IMMINGHAM EASTERN RO-RO TERMINAL

Appendix 1 to Proposed Changes Notification Report -
Environmental Statement Addendum
Document Reference: 10.3.3

October 2023

Figure 2.2. General Arrangement Plan showing Proposed Changes

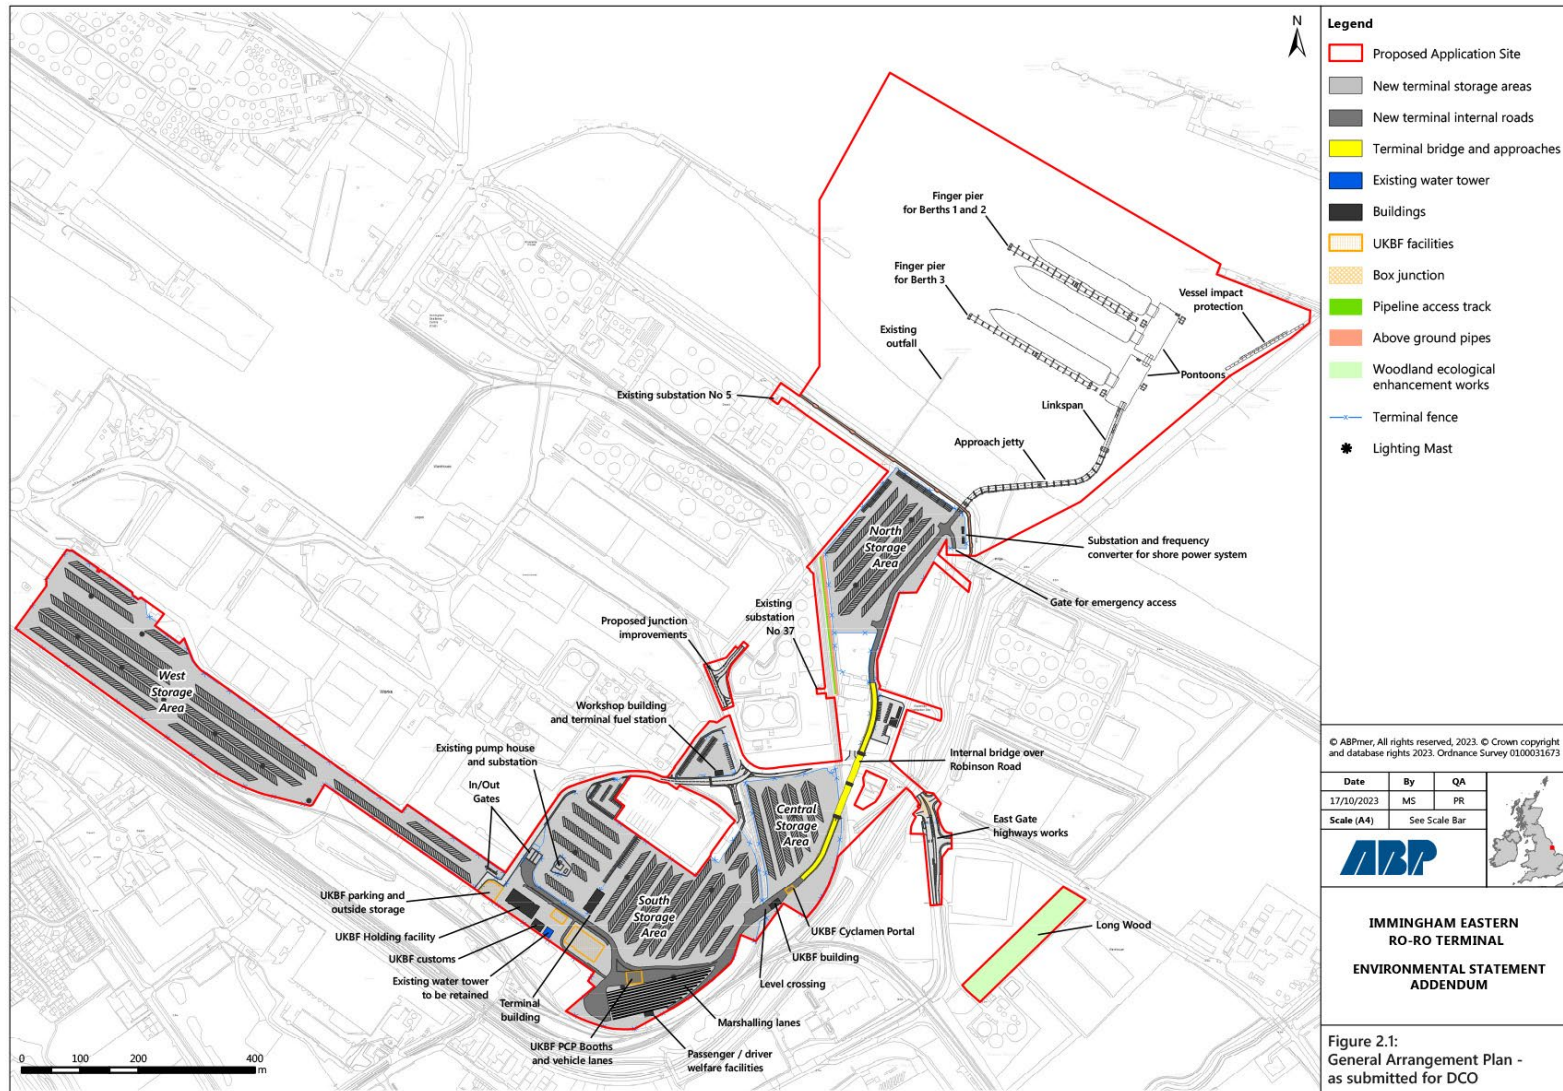
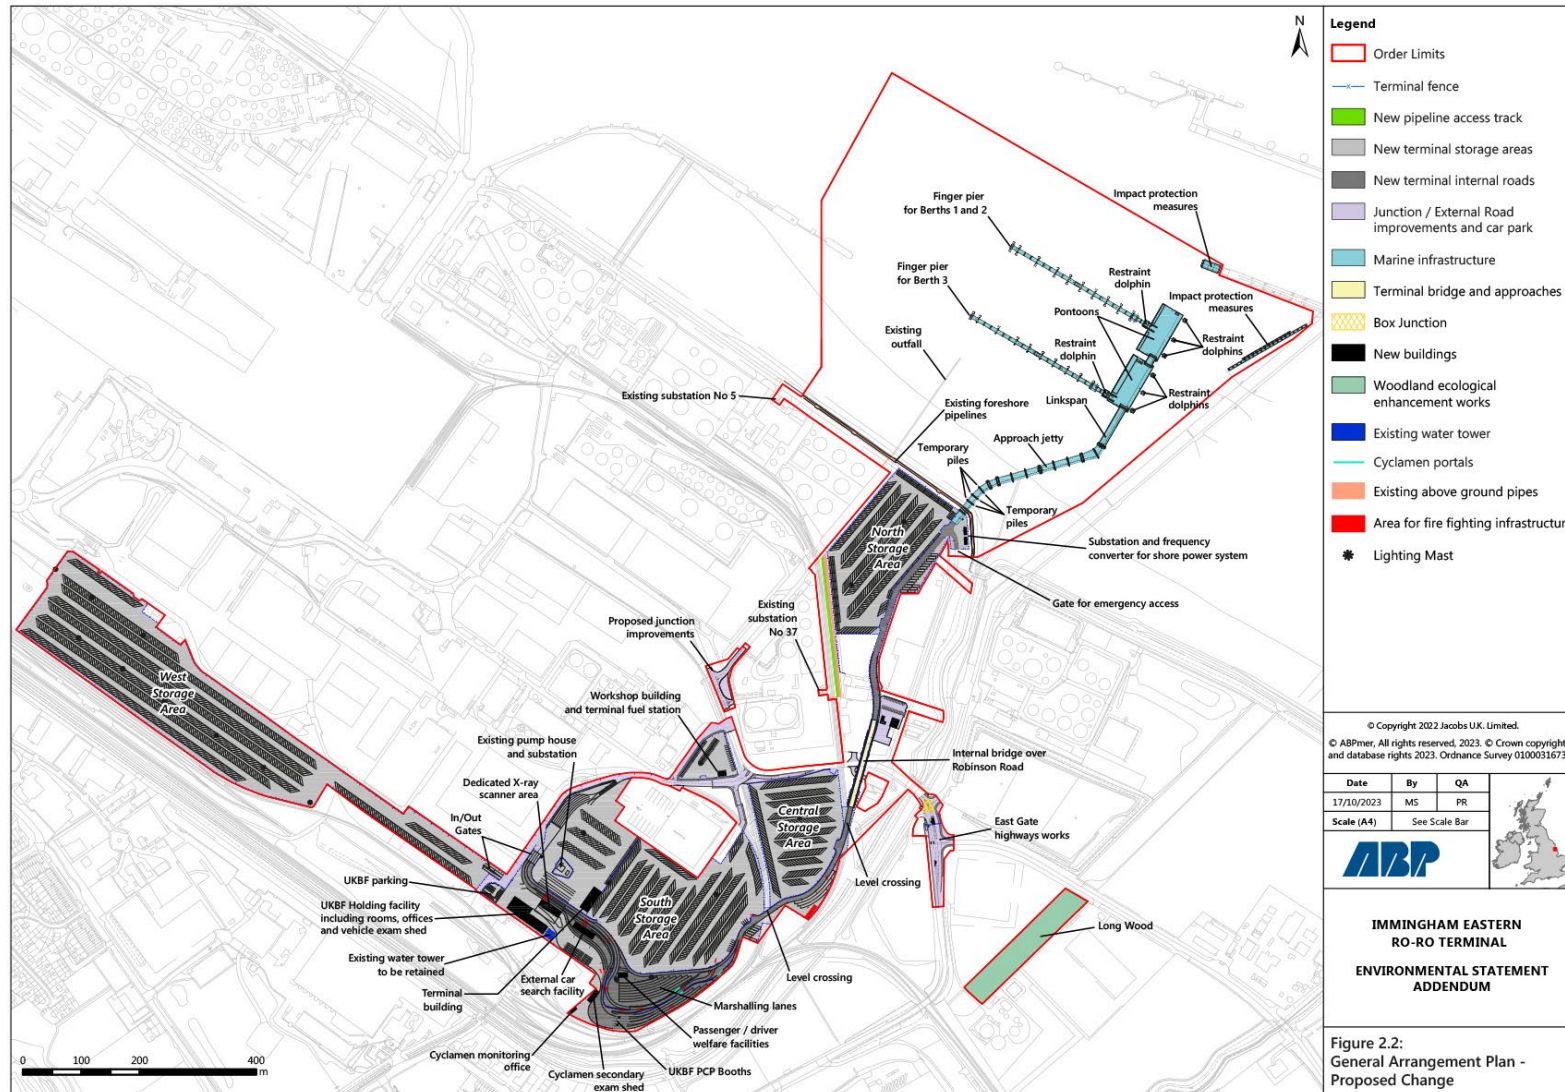
2.1.3 For ease of reference, Figure 2.1 shows the General Arrangement Plan as submitted for the DCO application. Figure 2.2 then shows the General Arrangement Plan with the Proposed Changes.

Figure 2.3. Proposed Change relating to marine infrastructure (Proposed Change 1 and Proposed Change 4)

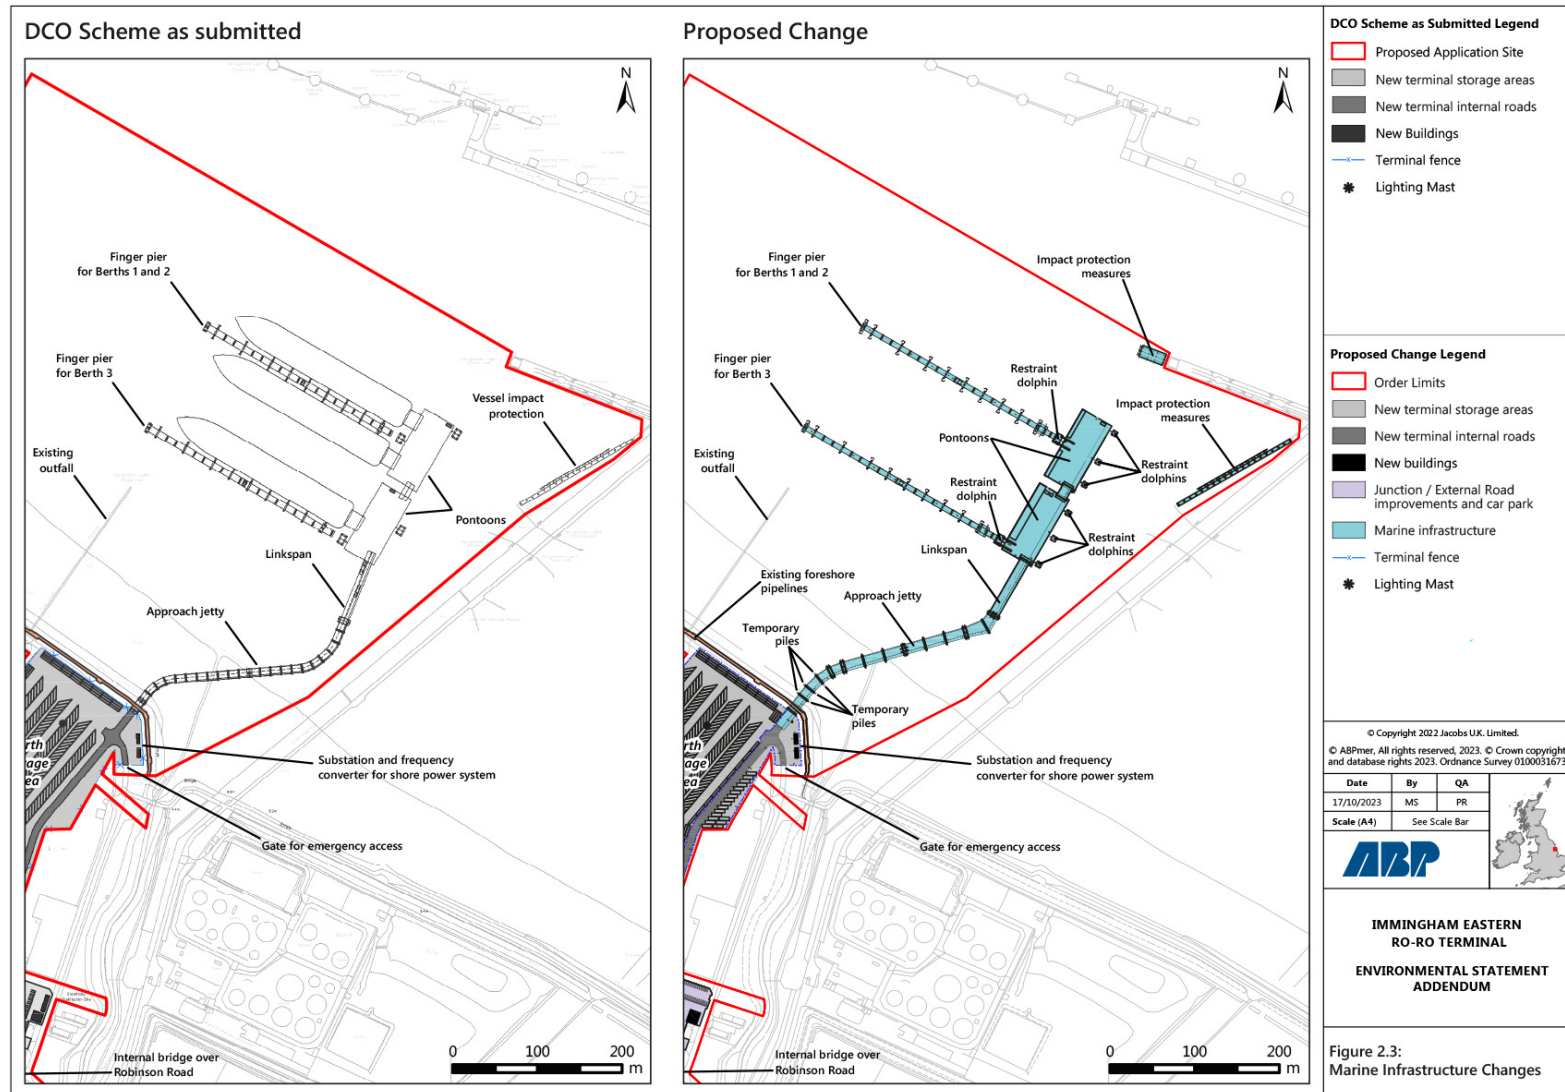
- 2.2.3 As part of the Proposed Changes, the approach jetty alignment has been straightened which moves the approach jetty away from Immingham Oil Terminal (IOT) marine infrastructure whilst still accommodating a suitable swept path for vehicular movement. A comparison of the alignments is shown in Figure 2.3.

- 2.2.4 The approach jetty itself will now be a maximum of 250 m in length, 12.5 m in width (though wider, up to 13 m, at the positions of the piles and up to 17 m at last set of piles before the linkspan (this to accommodate the swept path of HGVs)), and 13.5 m in height above chart datum (CD). The deck will be supported by a maximum of 46 piles. The abutment structure on the seaward side of the defences will also be repositioned and reduced from six piles to three (this is described in more detail below at paragraph 2.2.8). Six piles will be used for the linkspan bank seat (as per the originally proposed scheme). Therefore, the maximum number of piles for the approach jetty now totals 55. It should also be noted that, whilst the maximum diameter of piles for the approach jetty and finger piers remains 1,422 mm, a number of piles have also been reduced in diameter.

- 2.5.2 It is proposed that the impact protection measures would consist of an impact protection structure at the end of the IOT finger pier (see Figure 2.3). This will be in addition to the linear impact protection structure as originally described in paragraph 2.3.18 to 2.3.20 in Chapter 2 of the ES [APP-038] and included in Works Order no. 3 [APP-007]. The only change to the existing linear impact protection structure is that the pile diameter is proposed to be increased from 1,422 mm to 1,520 mm.

Figure 2.4. Proposed Change 2: Realignment and shortening of the IERRT internal bridge

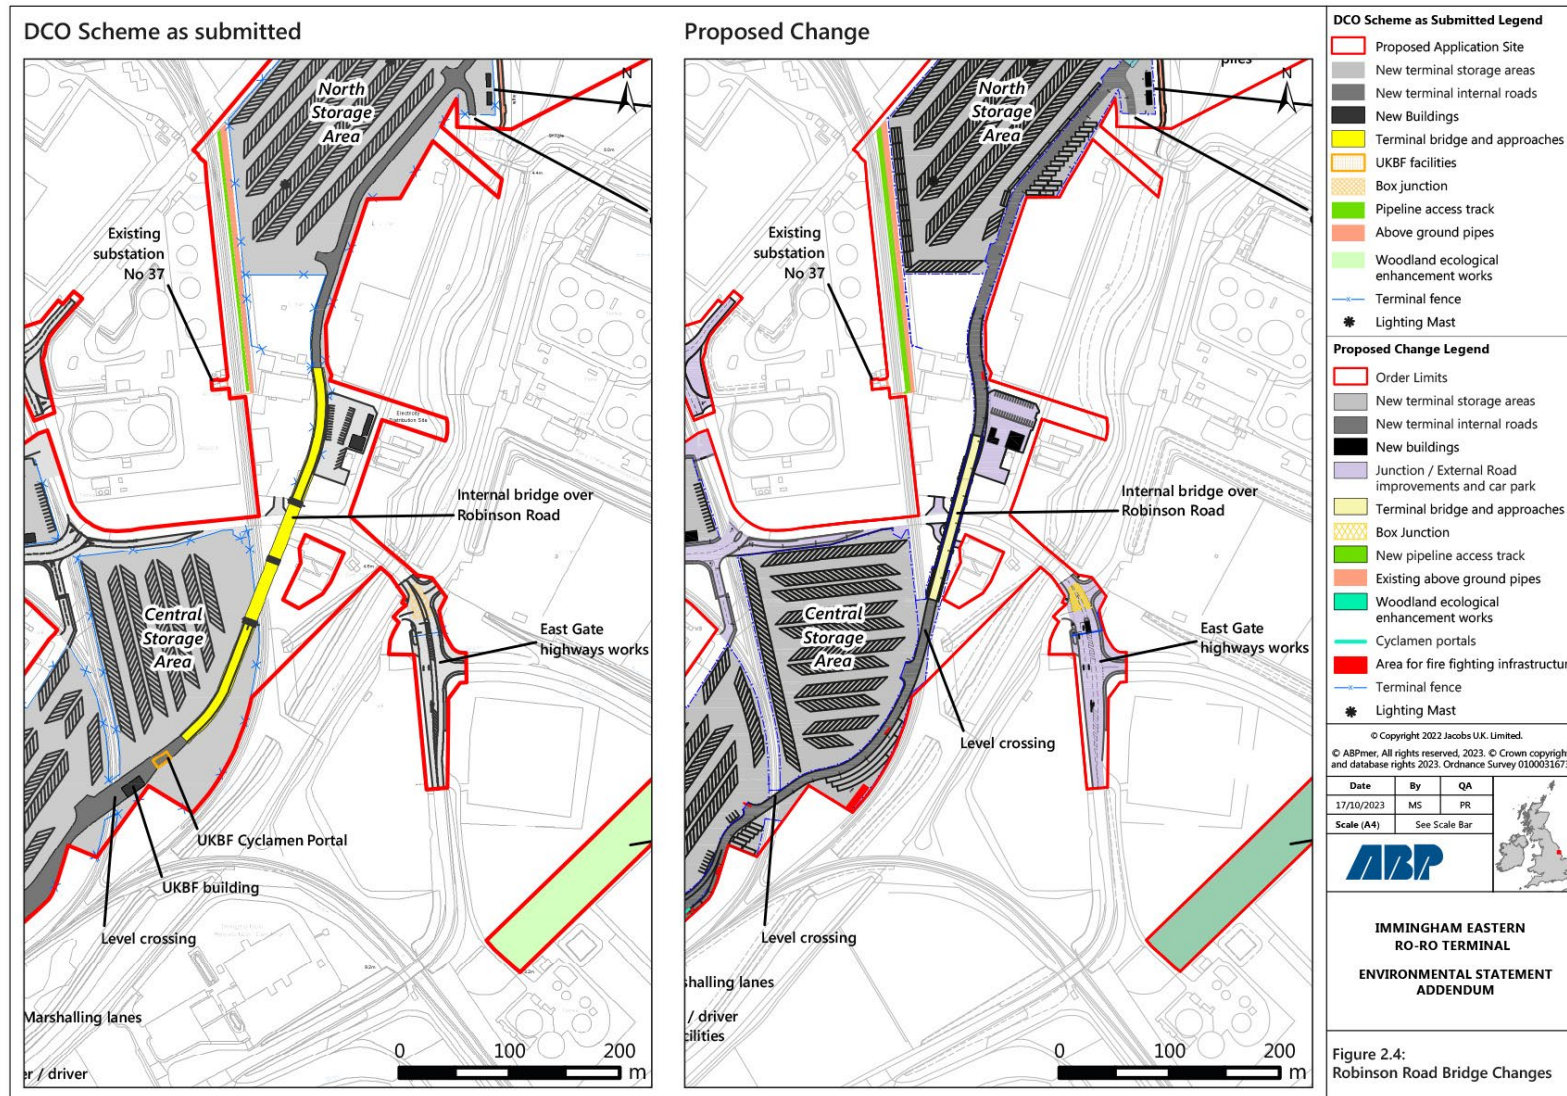
- 2.3.2 As part of the changes to the DCO application, it is proposed that this design is amended so that the bridge spans Robinson Road but not the ABP controlled railway spur line (Figure 2.4). The railway would instead be crossed via an at-grade (i.e., ground level) level crossing. The proposed bridge deck length has been shortened to 86 m with a maximum height of 11 m above the ground. The maximum width of the bridge would not increase.

- 2.3.3 It is necessary to make a minor amendment to the alignment of the southern end of the bridge, moving the alignment eastwards requiring an amendment to the limit of deviation shown in Works Order no 7 [APP-007]. This is to ensure there is sufficient space for the bridge to cross the railway line at ground level.

Figure 2.5. Proposed Change 3: Rearrangement of the UK Border Force facilities

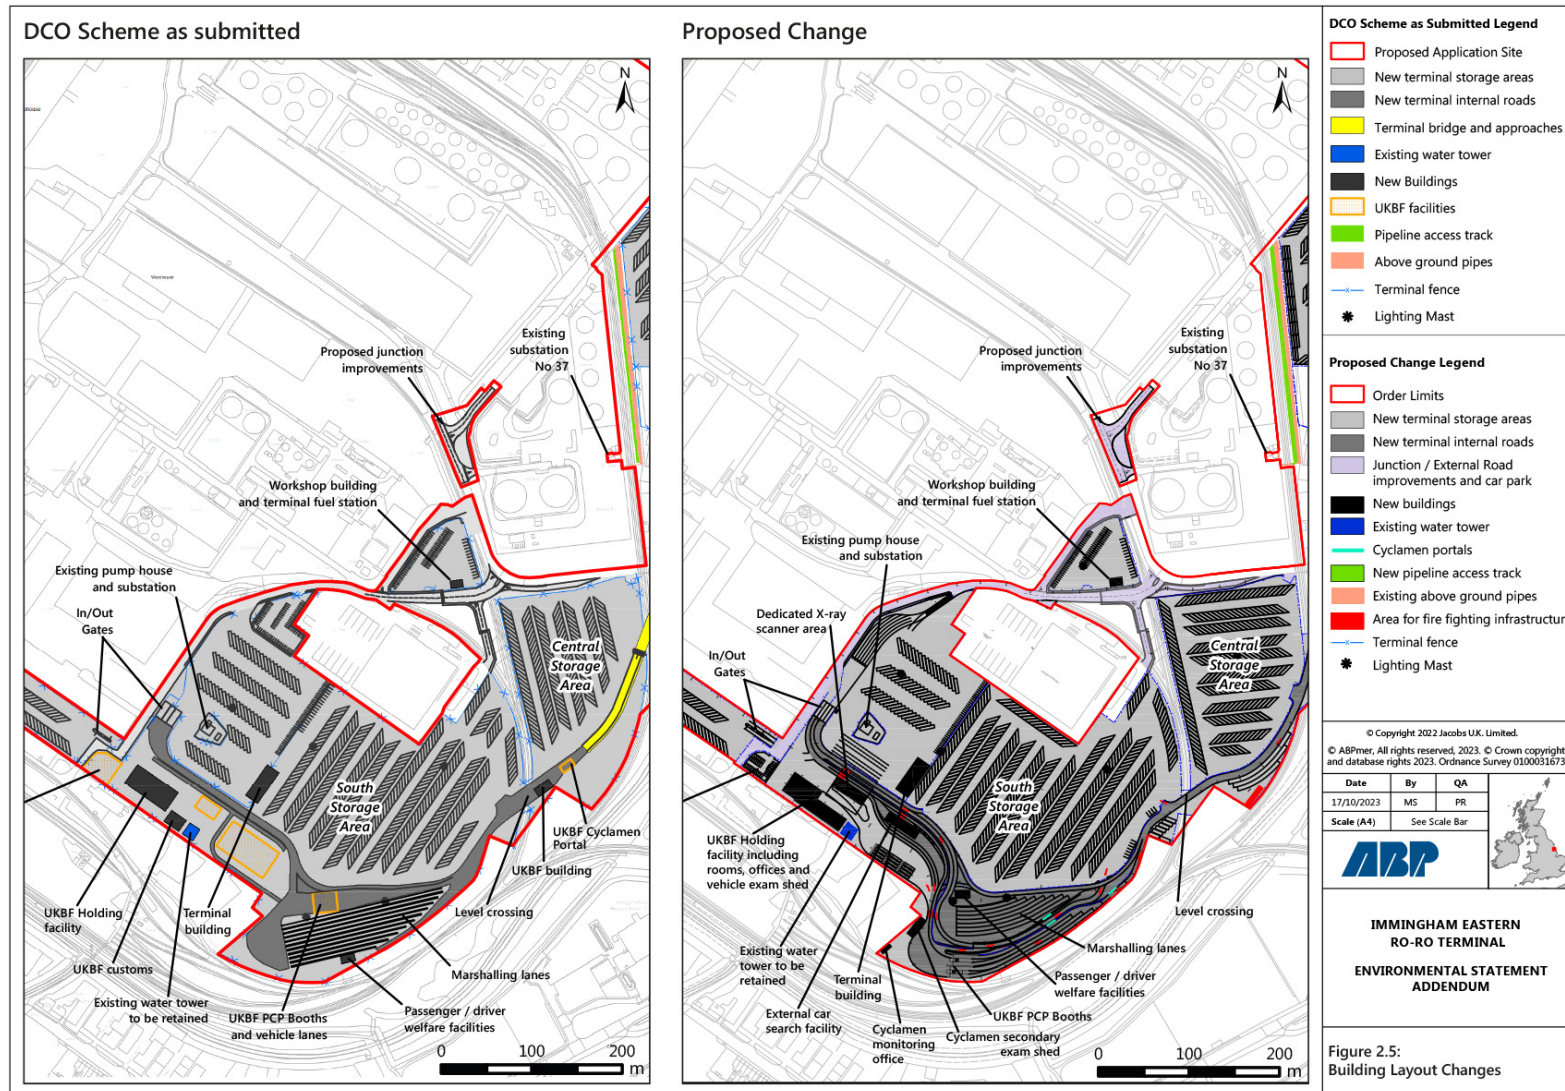
- **Cyclamen Search Building:** A minor relocation of the building is proposed within the limits of deviation with no change in size;
 - **Cyclamen Portal:** A minor relocation of the portal closer to the UKBF buildings is proposed within the limits of deviation to improve operational efficiency with no change in size; and

- **Passport Control Booth:** A minor relocation of the building is proposed within the limits of deviation with no change in size.
- 2.4.4 In consultation with UKBF, changes are also proposed to the operational layout. The inbound road and associated passport control booth (noted above) have been moved to the southern boundary requiring the shift of the marshalling lanes to move slightly northwards. Additionally, a new unaccompanied lane has been created between the passport control booth and the marshalling lanes to allow continues transit of unaccompanied freight and improve customs operations.

- 2.4.5 These changes are shown in Figure 2.5.
